AGENDA
PLANNING AND ZONING COMMISSION MEETING
CITY OF CREVE COEUR, MISSOURI
TUESDAY, JANUARY 19, 2021
6:30 PM

1. Application #21-001: Site Concept and Site Development Plan Approval for Mechanical Additions to Building K for Bayer at 10300 Olive Boulevard

3. Application #21-003: Minor Site Development Plan Approval for Renovations to 1200 Research Boulevard for a Plant Science Research Lab and Business Office

**APPLICATION TO PLANNING AND ZONING COMMISSION
#21-001: FOR A SITE CONCEPT AND SITE DEVELOPMENT PLAN
APPROVAL FOR MECHANICAL ADDITIONS TO BUILDING K FOR
BAYER AT 10300 OLIVE BOULEVARD**

Figure 1: Close-up of the proposed campus impervious plan showing the west campus area.

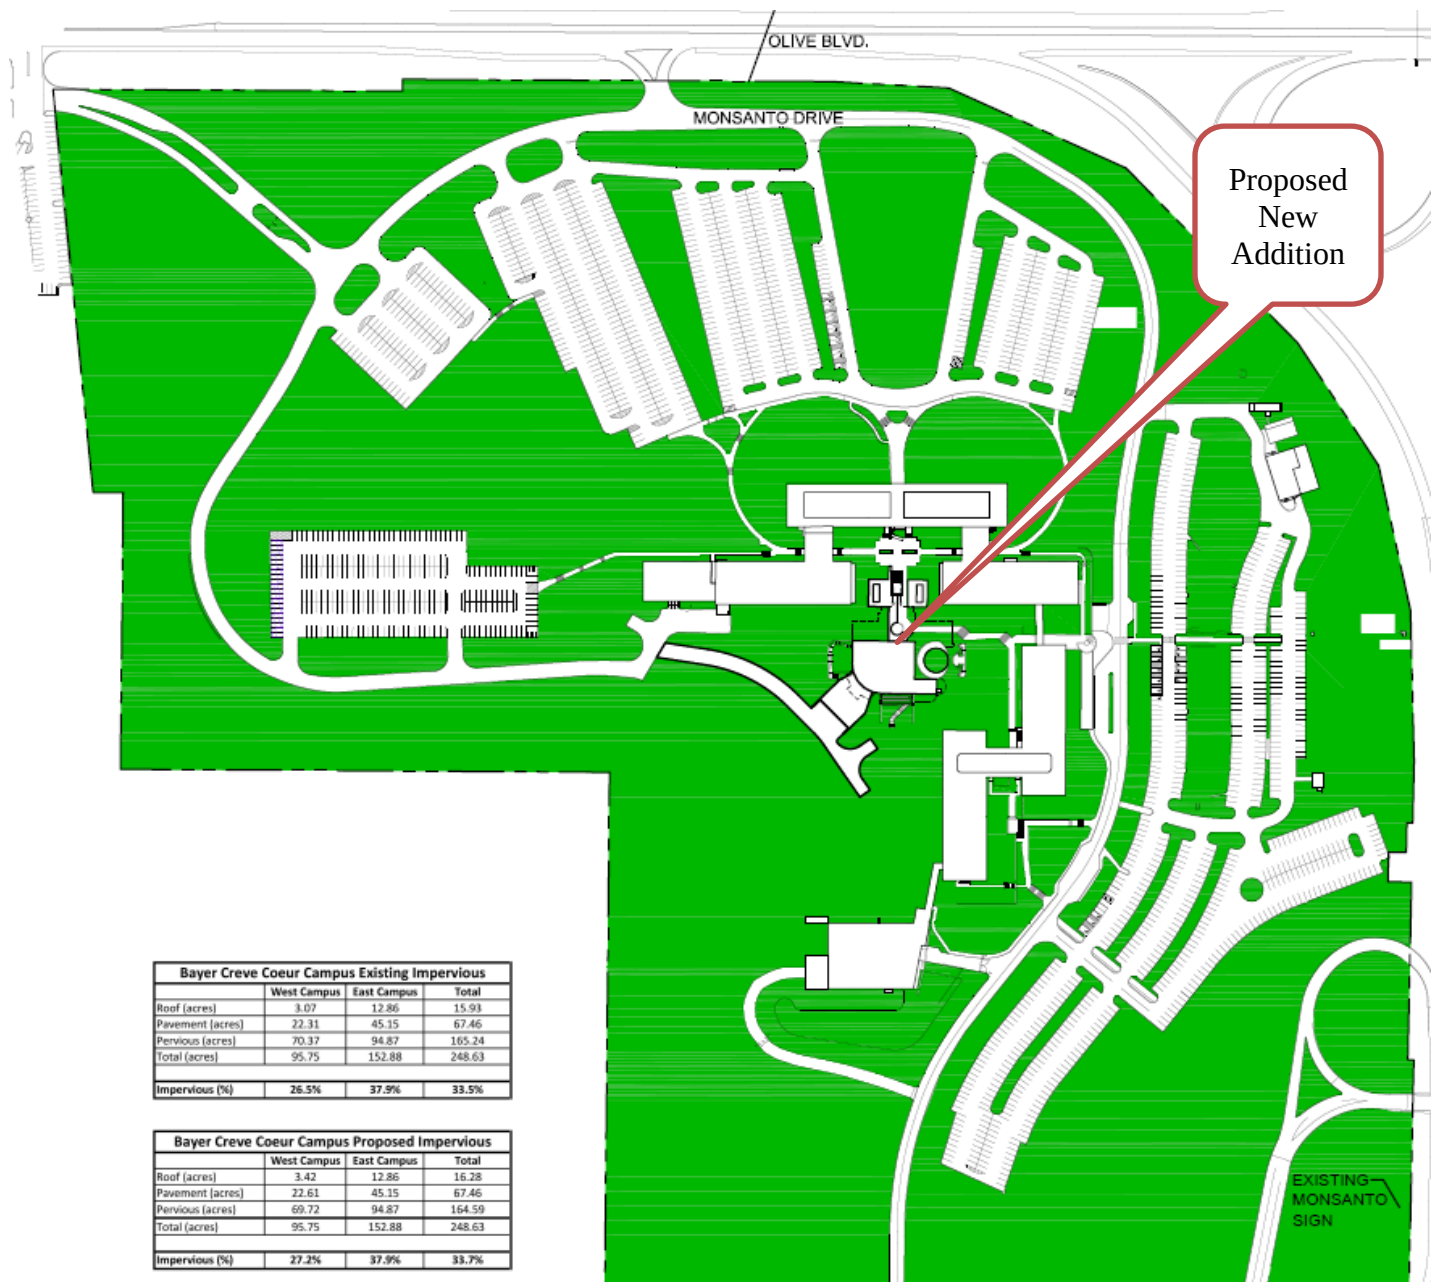
The subject properties are zoned RO District where Section 405.330(D) requires site concept plan and site development approval by the Planning and Zoning Commission for all proposed developments within the "RO" District as provided for in Section 405.1080. As stated above, the proposal will add approximately 29,196 square feet of new coverage, with the building addition and new emergency access drive aisle. Thus, review of the proposed development is necessary.

Under Section 405.330(E)(4) the RO District has a building setback of 50 feet on all sides and an additional buffer yard requirement of shall provide a buffer yard of 25 feet on all sides that abut the single-family district. The minimum required buffer yard shall be increased in 5-foot increments, up to a maximum of 50 feet, for each acre of the subject property. All acreage shall be rounded up to the next whole number for buffer yard calculation purposes. An additional two (2) feet of buffer yard shall be provided for every foot of building or structure height exceeding forty-five (45)

Figure 11: Applicant's Rooftop Plan. The red indicates where there is no Mechanical Screening that would fully enclose the equipment.

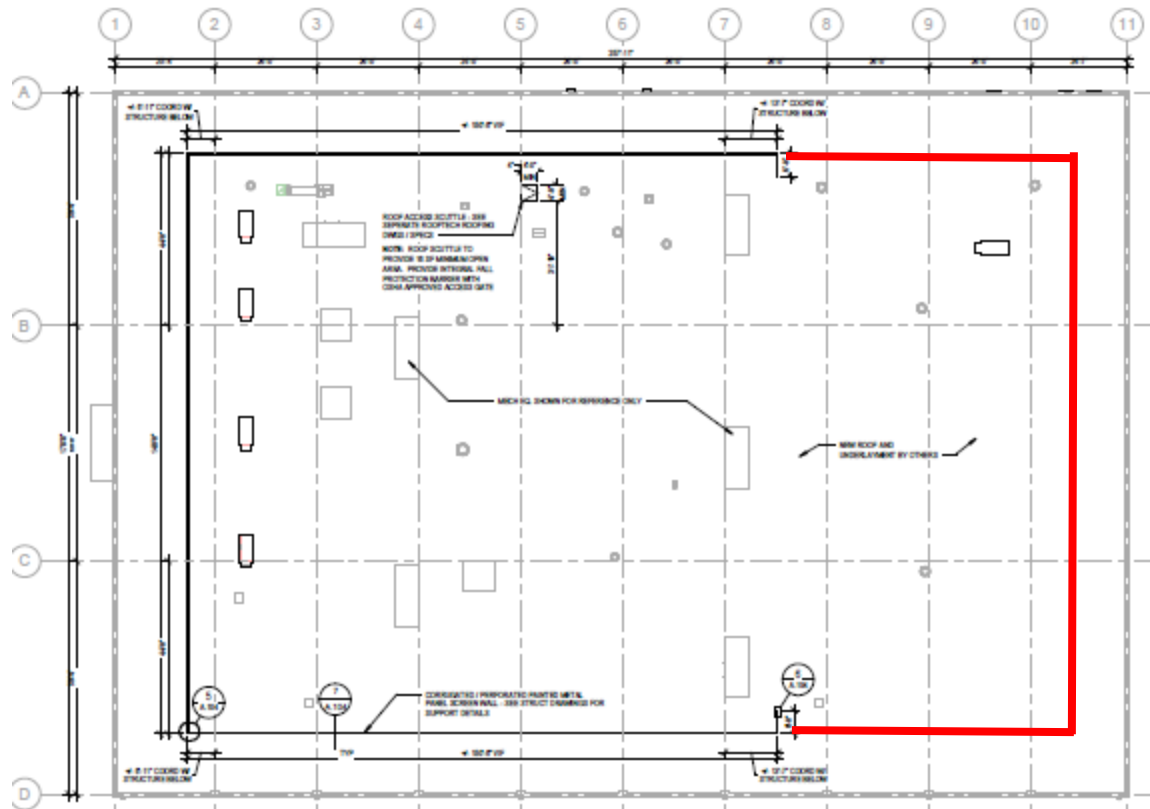
The renovation of the existing building for the proposed use will require a new roof and mechanical equipment on the building, as well as the outdoor ground mounted equipment within the existing parking lot. The Applicants are proposing a metal screen for the roof top equipment, in a color to match the building. Given the pre-existing nature of the building, Staff finds that the metal screening is sufficient for this location. However, the enclosure does not fully connect along the east end of the building, and the elevations show that it sits up with the mechanical equipment visible at the bottom, and that there are a few vents located outside of the screen area. The Commission should discuss with the Applicant whether this should be fully enclosed, expanded to encompass all of the equipment, or if the screening as proposed is adequate, and if the existing parapet will provide sufficient screening to fully screen the equipment from view.

The proposed equipment enclosure is utilizing split faced CMU where the existing structure is a brick structure. The Applicants indicated that the color could be made to match the existing building. The location is appropriate for this site, and there is limited space to provide it elsewhere, however it would be visible from Research Boulevard and should the further proposed 39N Greenway Connections go in would be visible from the proposed pathway. Therefore, Staff recommends that the enclosure be faced with a brick to match the existing building on the site, and have included a condition for such. The Commission should discuss the options with the equipment enclosure with the Applicant and revise the recommended conditions of approval, if necessary. Further, the Applicant is showing that the east yard will have the existing abandoned railway spur completely removed and infilled with new compacted gravel to maintain existing grades. A new concrete walkway, site stair and associated lighting would be installed. If the Commission finds that the use of CMU is appropriate for this setting, Staff recommends that additional landscaping be provided to screen the structure from view, and that the use of gravel on the east side of the building be replaced with new sod/grass lawn to be consistent with the landscaping throughout the site, and with the recommendations of the Design Guidelines, and the 39N Master Plan, and Greenway Plan.

Figure 13: Close-up of the Site Development Plan showing the sidewalks in front of the building, and the GIS Image of the existing area. The area in red indicates the sidewalk recommended by Staff for the curb stops in front of the existing parking.

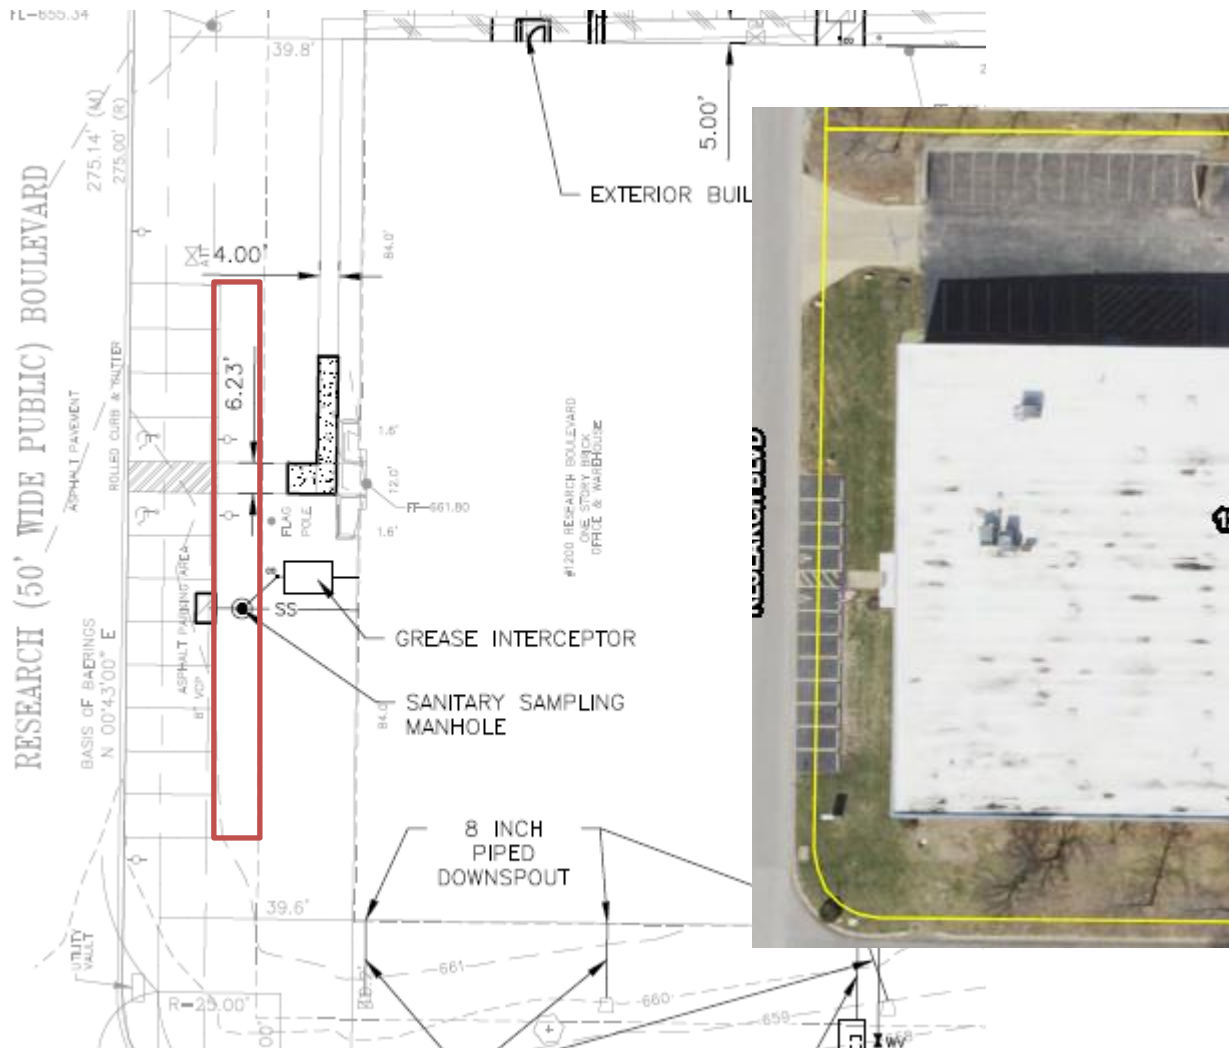
The sidewalks are shown at 4 feet in width, with 6 feet from Research Blvd to the front entrance, and currently no sidewalk is provided along the front of the parking spaces at Research Blvd. The new side walk along the east of the building is also shown at 4 feet, where Section 405.730(A)(2) requires a minimum width of internal sidewalks in non-residential developments shall be at least six (6) feet or eight (8) feet if used as a curb stop. Staff has included a condition that the new sidewalk from the north side of the building to the main entrance shall be a minimum of 6 feet. The exception for the pedestrian exits at the rear of the building, at 4 feet as this is just for emergency access from the building, and not intended for public entrance. Additionally, Staff recommends that an 8-foot-wide walk along the pre-existing non-conforming parking along Research Boulevard be provided.

Figure 14: Interior Floor Plan showing the business/office areas versus the storage/growing facilities.

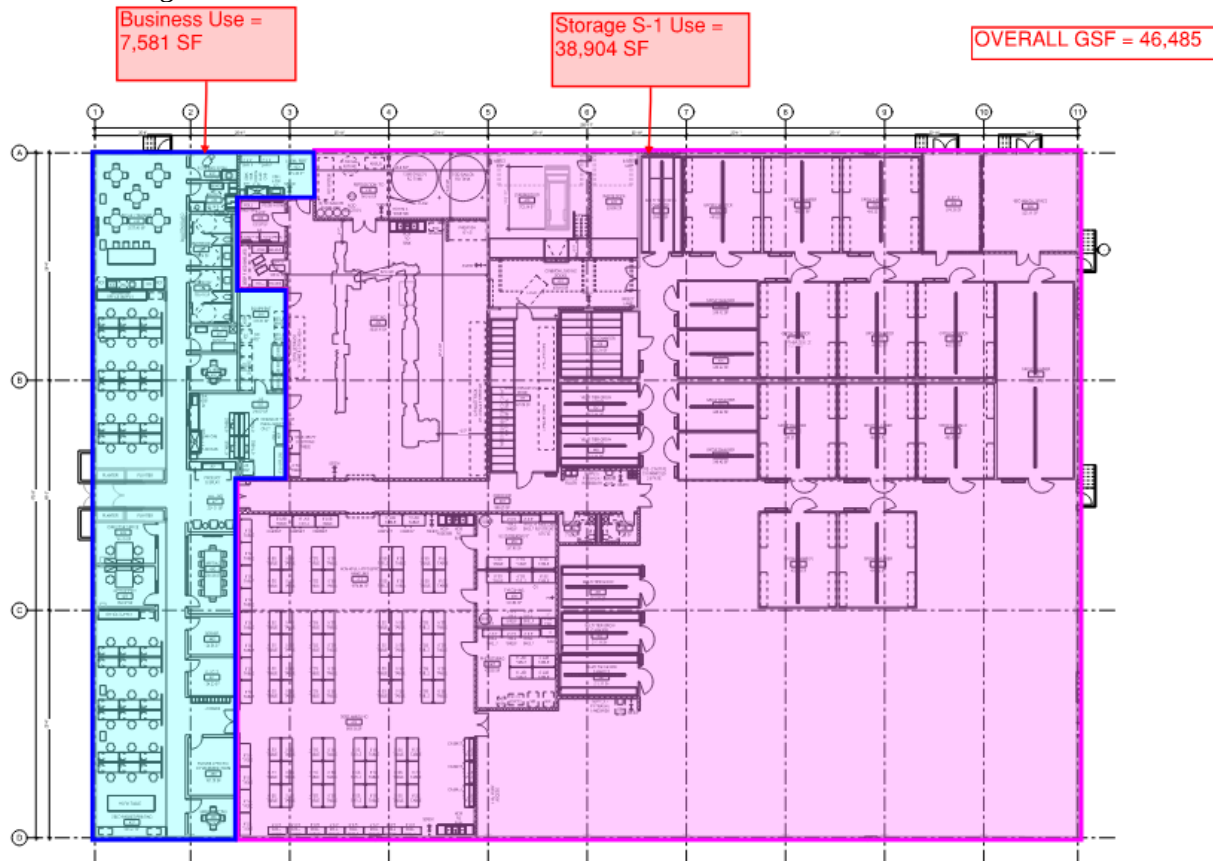
The parking spaces are also not dimensioned, but the Applicant has indicated that they do not appear to conform with the minimum stall widths of depths under Section 405.810(A)(1)(a)
